Product Information Notice

Models: R2107 Controller

Subject: R2107 Factory Mis-wire

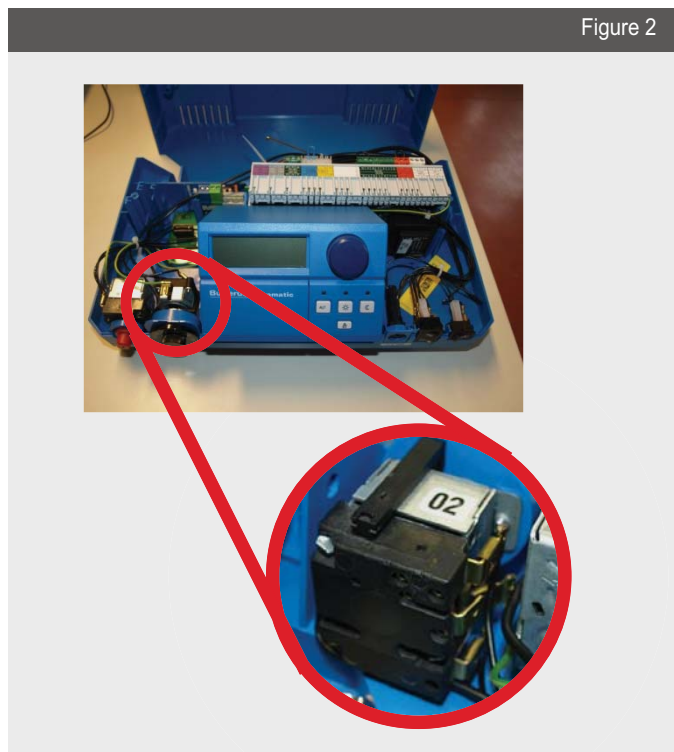
R2107 controllers manufactured in 2013 contain a TR component (Fig. 2) that may have been mis-wired from the factory. The ground connection wire (yellow-green wire) on the TR component may be attached to the incorrect terminal. This mis-wire can lead to a blown internal fuse and/or tripped circuit breakers.

All uninstalled R2107 controllers should be inspected for the factory mis-wire in the field. If a mis-wire is discovered the product can be returned through the RMA process.

Any installed R2107 controllers that are blowing fuses or tripping breakers should be inspected for the mis-wire, if found the R2107 controller should be replaced and returned through the RMA process.

Fig. 3 - Correctly wired:

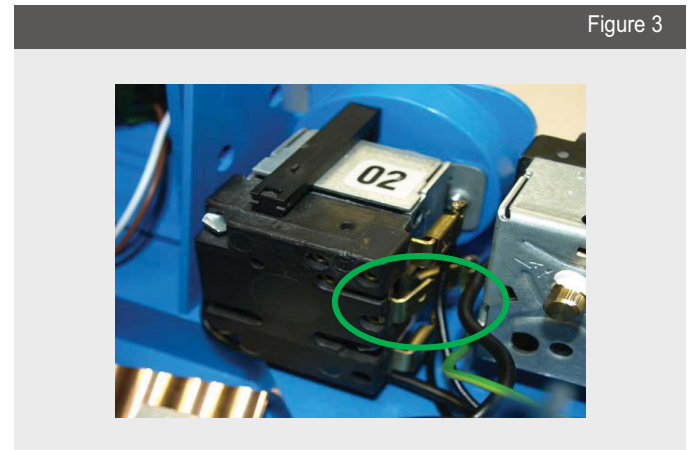
Incorrectly wired: middle terminal on TR component with ground wire (yellow-green wire) connection attached.

middle terminal on TR component open. Ground wire (yellow-green) must be attached to metallic housing of TR component.
